City of Saco, ME
Planning Board Agenda
Tuesday, March 30, 2021 – 5:30PM
Regular Meeting & Public Hearings
Location: Remote via [Zoom.us](https://zoom.us)
All votes to be taken by roll call.

City of Saco, ME
Planning Board Meeting Minutes
Tuesday, March 2, 2021 – 6:00PM
Regular Meeting & Public Hearings
Location: Remote via Zoom.us
All votes taken by roll call.

PLOT PLAN, #66 OLD ORCHARD ROAD, SACO, MAINE
 MADE FOR MANN ENTERPRISE, INC. APRIL 13, 2020
 BY OWEN HASKELL, INC.

DATE: 9/8/2020
 SCALE: 1"=20'
 DESIGNED: MTW
 JOB NO: 2052
 FILE: 2052-BASE.dwg
 SHEET: C-2.0

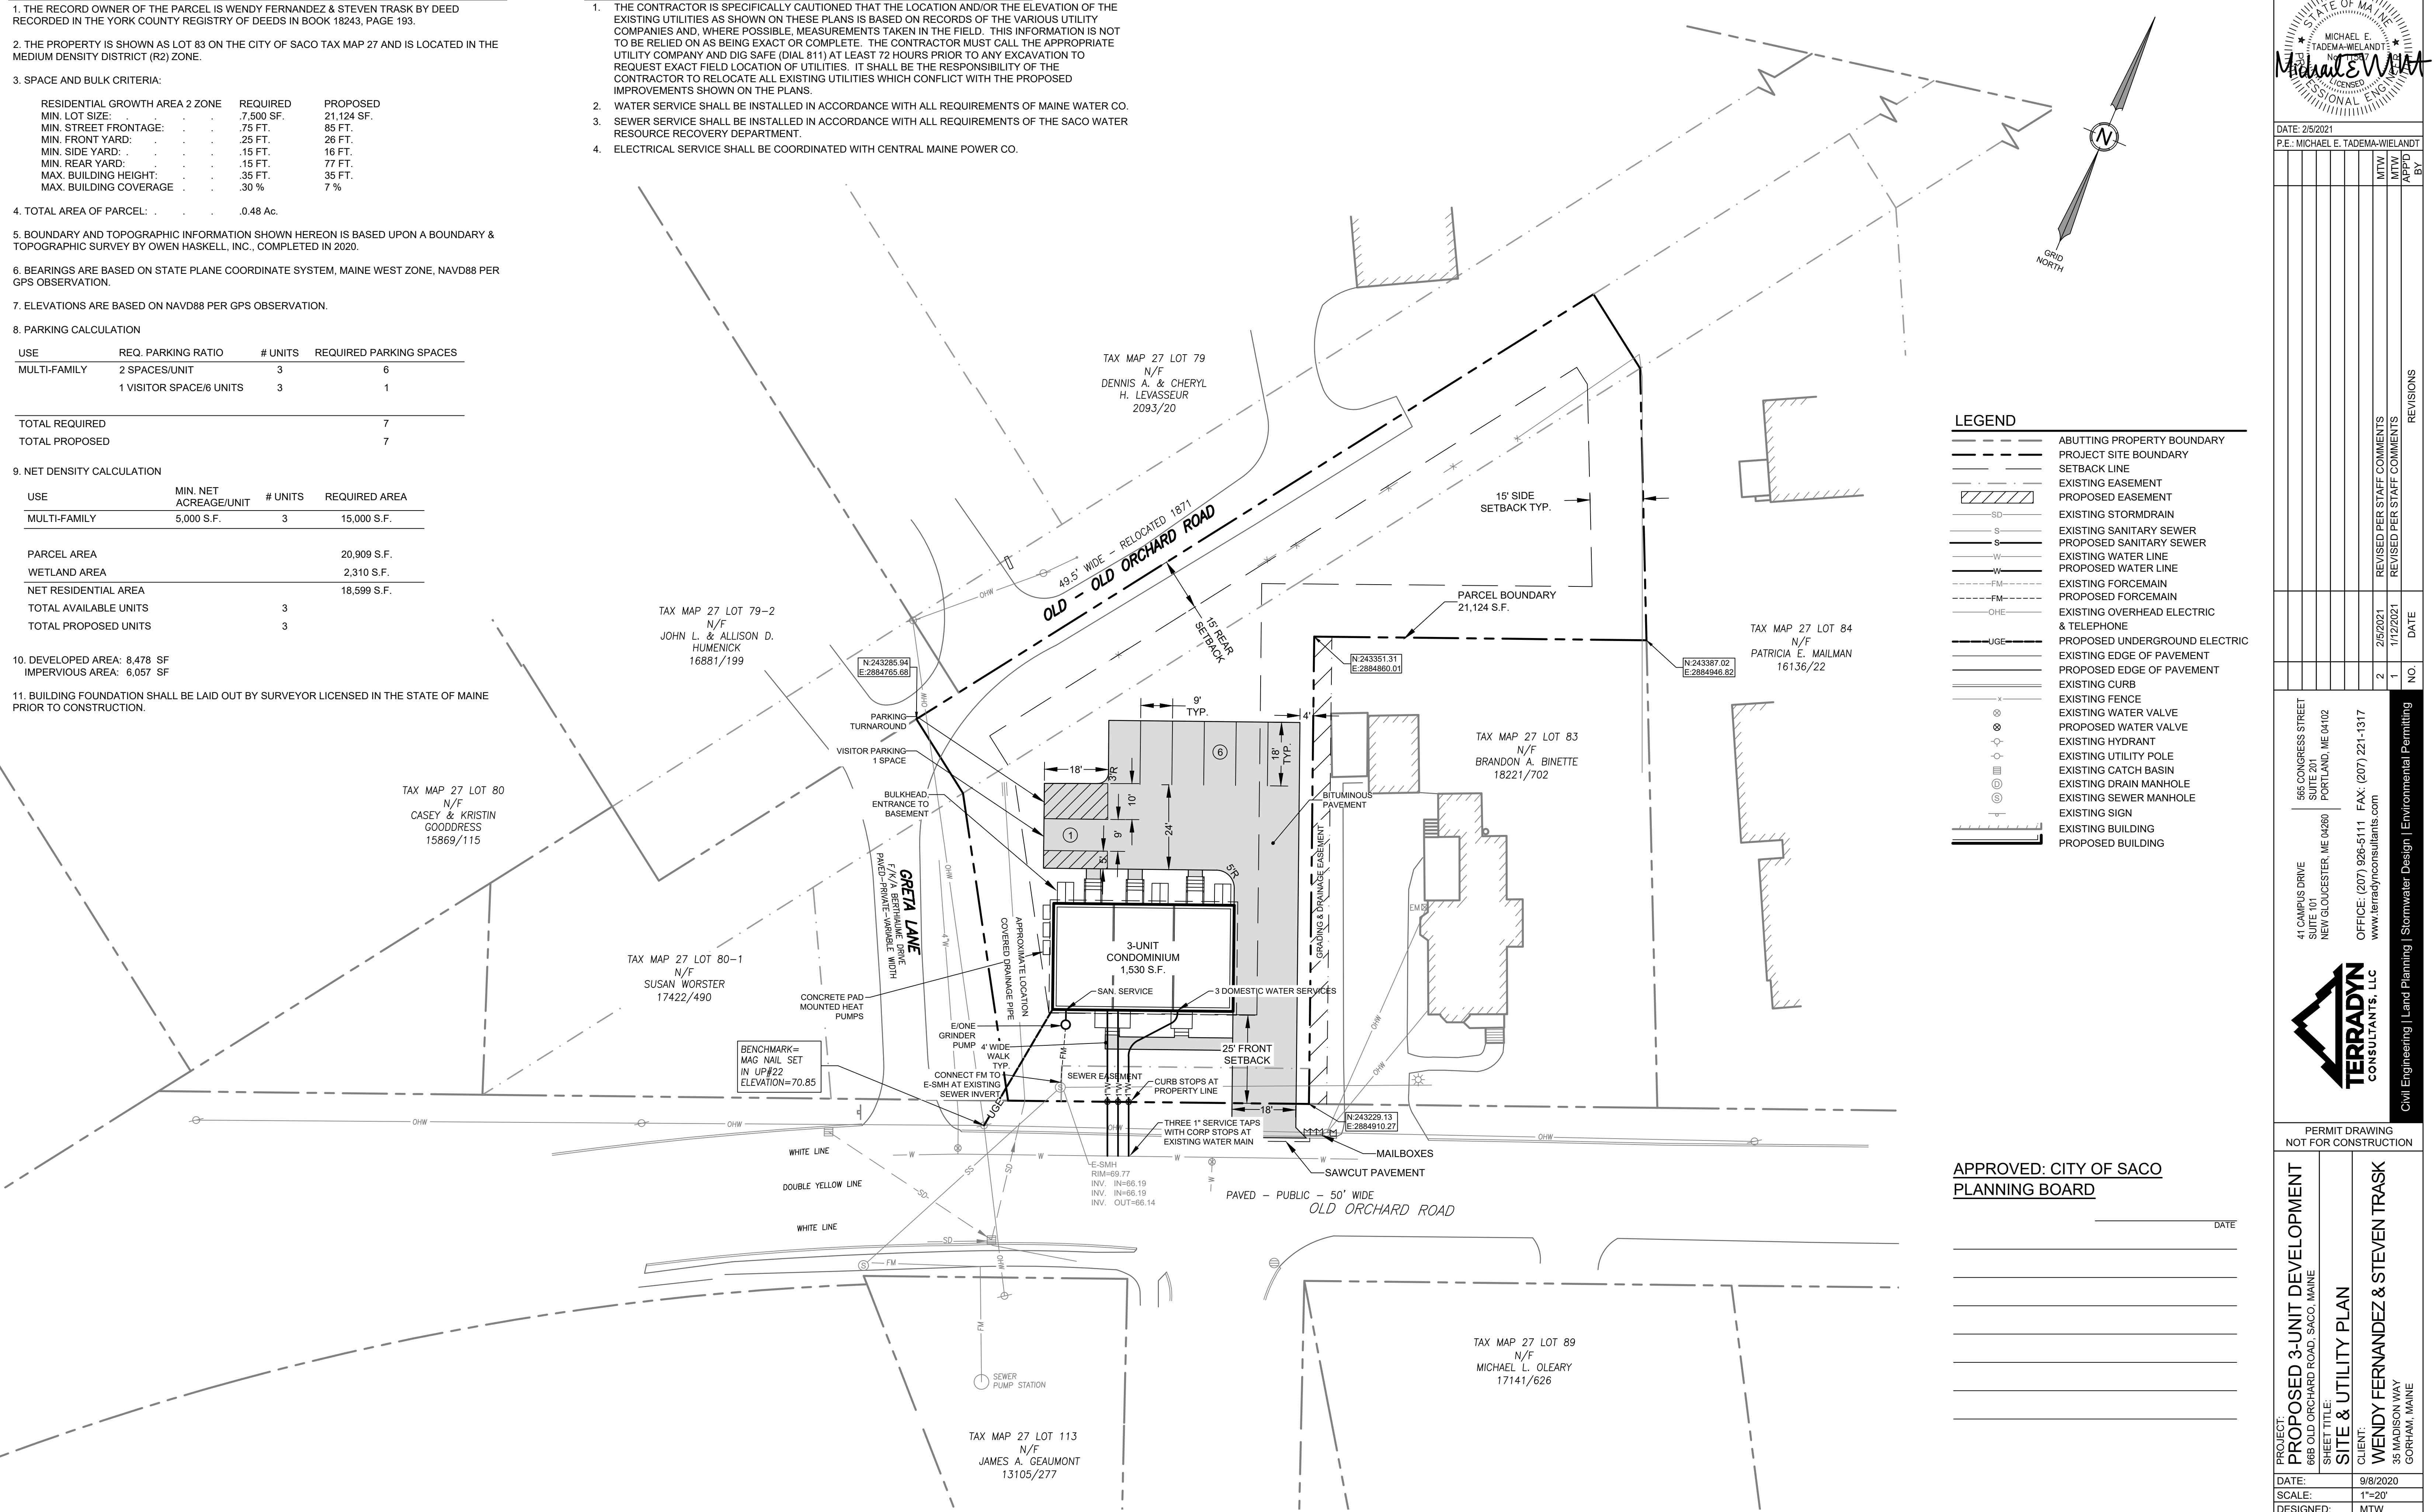
Comment 4: A Planning Board signature block should be added to Sheet C-2.0 of the plan set.

Comment 6: A note should be added to Sheet C-2.0 of the plan set summarizing the net residential density for the site.

Comment 7: A note should be added to Sheet C-2.0 summarizing the off-street parking requirements in accordance with Table 708-2 of the Zoning Ordinance.

1. The ACOE wetland permitting note added to sheet C-1.0 should also be added to sheet C-2.0.
2. The location of the building foundation perimeter drain discharge should be shown on the plans.
3. If the grading easement is not secured prior to approval, then we would recommend the following condition of approval:

Response: A Planning Board signature block has been added to Sheet C-2.0.

Response: A note has been added on Sheet C-2.0 summarizing net residential density for the site.

Response: A note has been added on Sheet C-2.0 summarizing off street parking requirements for the site.

Response: The United States Postal Service (USPS) has verified that the project should be served by 3 separate mailboxes located at the end of the proposed driveway. Mailbox locations have been added to the Site & Utility Plan (Sheet C-2.0).

Response: A note has been added to Sheet C-2.0 requiring that the building foundation be laid out by a licensed surveyor prior to construction.

Response: Underground electrical electric, telephone and communications services are shown on the revised Site & Utility Plan (Sheet C-2.0).

Response: The building will likely be heated and cooled using heat pumps with pad mounted equipment. The locations of individual pad mounted equipment have been added to the Site & Utility Plan (Sheet C-2.0).

SHEET **P-1.0**

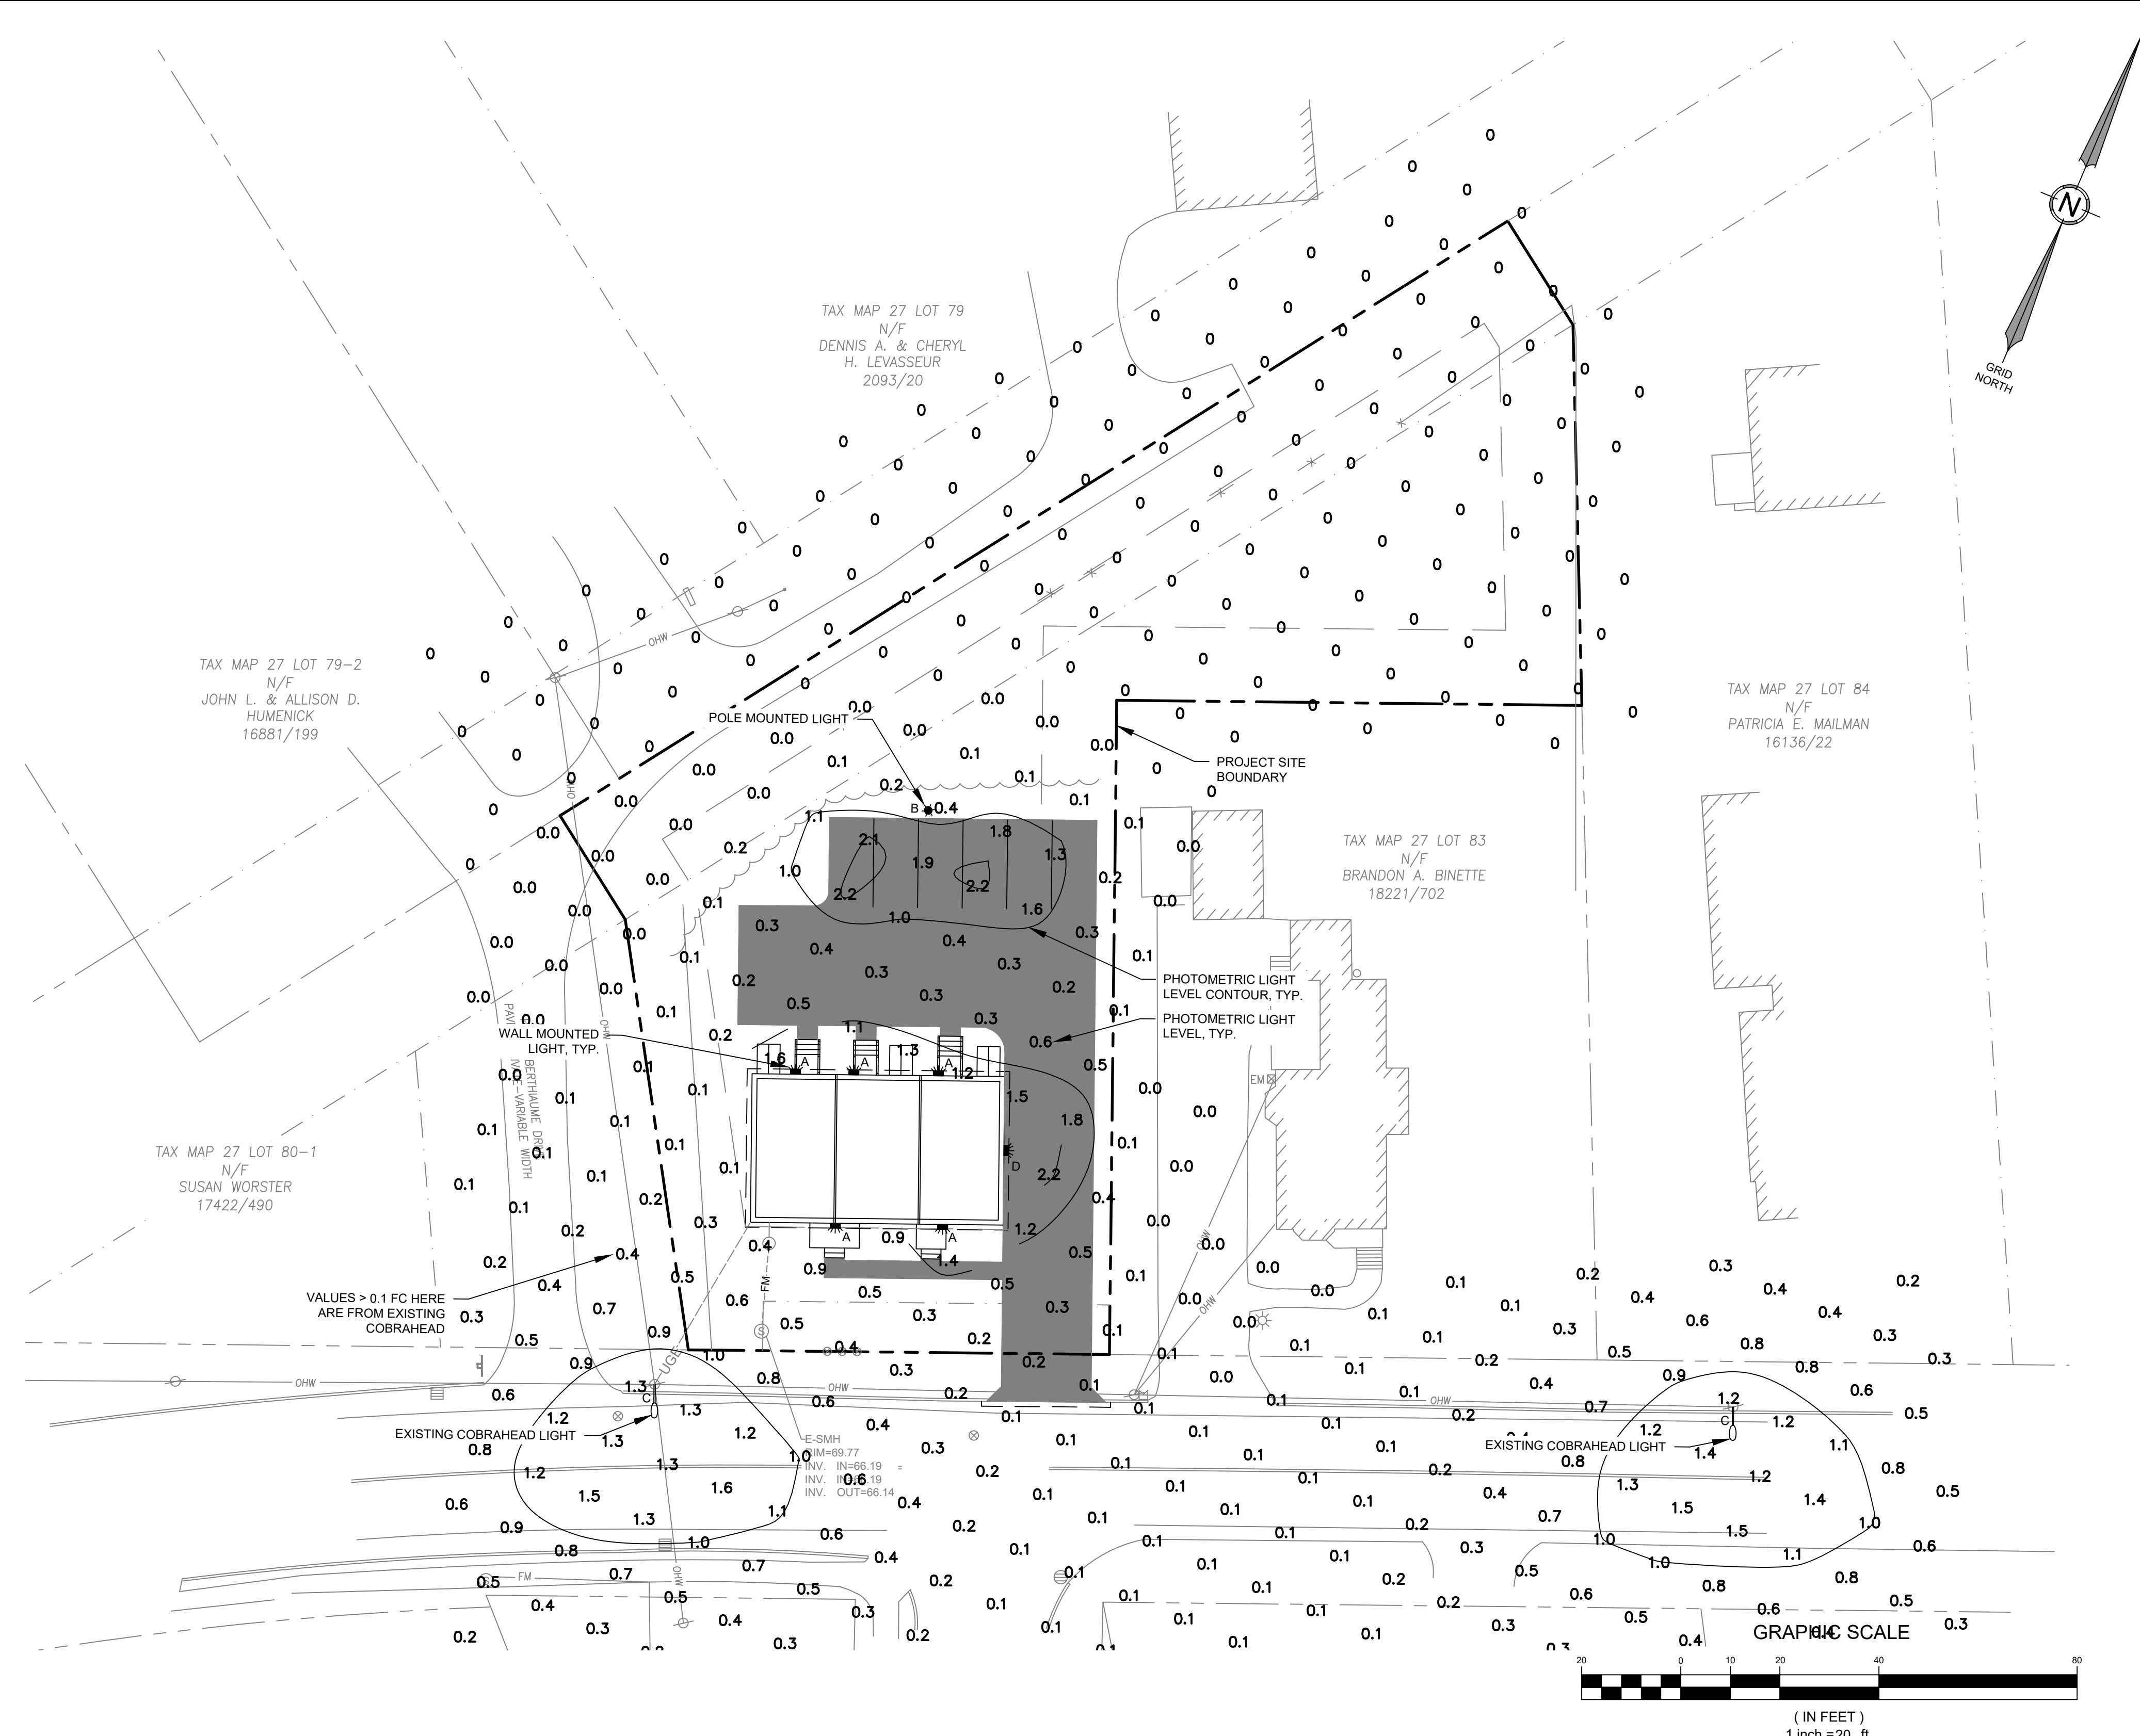
PEER REVIEW COMMENTS 03-24-2021: drawing P-1.0 under "SACO LIGHTING STANDARDS" "PROVIDED VALUE ACCESS DRIVE UNIFORMITY ": states compliance with requirement. Illustrate on drawing the calculation points used for compliance calculations, without contribution from the two City of Saco cobra-head streetlight

PEER REVIEW COMMENTS 03-24-2021: drawing P-1.0 under "SACO LIGHTING STANDARDS" "PROVIDED VALUE PARKING LOT UNIFORMITY ": states compliance with requirement. Illustrate on drawing calculation points used for compliance calculations, without contribution from the two City of Saco cobra-head streetlight

PEER REVIEW COMMENTS 03-24-2021: This project has two City of Saco cobra-head luminaires mounted at per drawing P-1.0 at 32'-0" assumed height above pavement. Will the City of Saco Planning Staff or the Planning Board accept illumination levels contributed to the project as a basis for compliance? Project should be resubmitted only with the luminaires on the actual property.

Response: A site lighting plan has been prepared for the site. The plan includes one pole mounted light and several wall packs. A copy of the Lighting Photometric Plan (Sheet P-1.0) is attached for review.
